WANDLE DELTA MASTERPLAN
A submission by Wandle Valley Forum on the draft Supplementary Planning Document

March 2021

WANDLE DELTA MASTERPLAN – Key principles

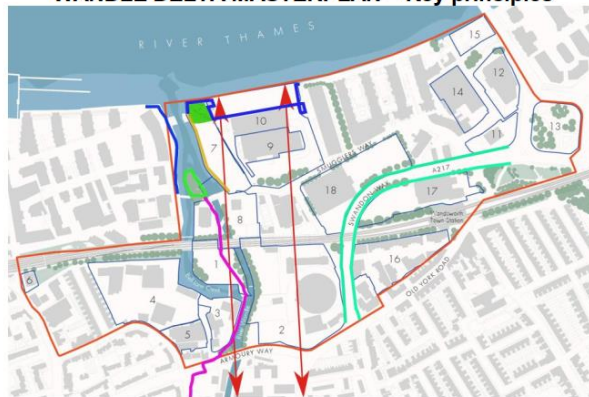
6. We believe the SPD can be strengthened in the following ways (with examples of relevant paragraphs):

- Identify the Wandle Trail in Figures 22, 23 and 40 consistent with the commitment to make this “*a focus for the whole area*”, and include its route south of Armoury Way (para 5.2.3)
